Access Compliance Report

Public Rights-of-Way

(Curb Ramps)

Intersection ID: 50594	Main Street: BEAR_GRASS_LN	Cross Street: GRAY_WILLOW_RD	Location:	N
ADA ID: EEEB376384DE	Ramp Type: Perp	Initial Pass/Fail: Fail	Overall Compliance: No	Severity Score: 10

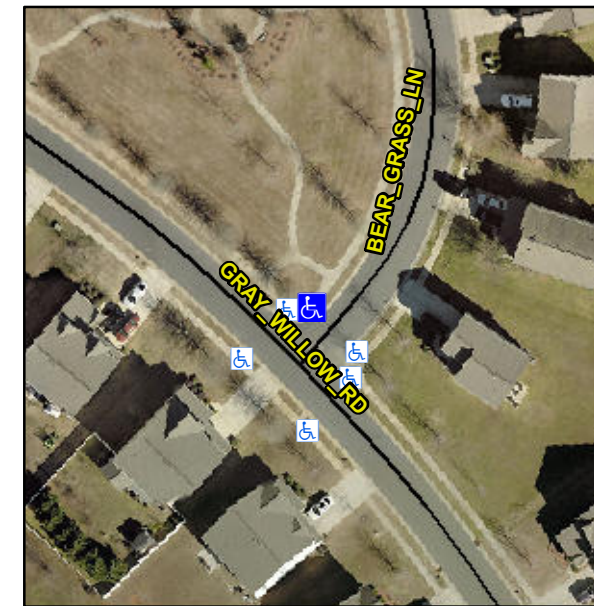
Not Found, R304.5.1, R304.5.3

Compliance	Description	Data	Compliance	Description	Data
N/A	Ramp Length (in)	51.5	Yes	Ramp Slope (%)	7.3
No	Ramp Width (in)	46.0	No	Ramp XSlope (%)	2.9
N/A	Flare Type LT	N/A	N/A	Flare Type RT	N/A
N/A	Flare Slope LT (%)	N/A	N/A	Flare Slope RT (%)	N/A
N/A	Flare Traversable LT?	N/A	N/A	Flare Traversable RT?	N/A
N/A	Landing Length (in)	N/A	N/A	DWS Provided?	N/A
N/A	Landing Width (in)	N/A	N/A	DWS Contrast?	N/A
N/A	Landing Slope (%)	N/A	N/A	DWS Length (in)	N/A
N/A	Landing X Slope (%)	N/A	N/A	DWS Full Width?	N/A
N/A	Landing Curb? (Y/N)	N/A	N/A	DWS Offset (in)	N/A
N/A	Shared Landing?	N/A			
N/A	Gutter Ponding?	N/A	N/A	Gutter Slope (%)	N/A
N/A	Gutter Lip Ht (in)	N/A	N/A	Gutter X Slope (%)	N/A
N/A	Painted X Walk1?	No	N/A	Painted X Walk2?	N/A
	X Walk 1 Direction	To SE		X Walk 2 Direction	N/A
N/A	X Walk 1 Width (in)	N/A	N/A	X Walk 2 Width (in)	N/A
	X Walk 1 Slope (%)	0.4		X Walk 2 Slope (%)	N/A
	X Walk 1 X Slope (%)	2.8		X Walk 2 X Slope (%)	N/A

Remove & Replace Entire Ramp.
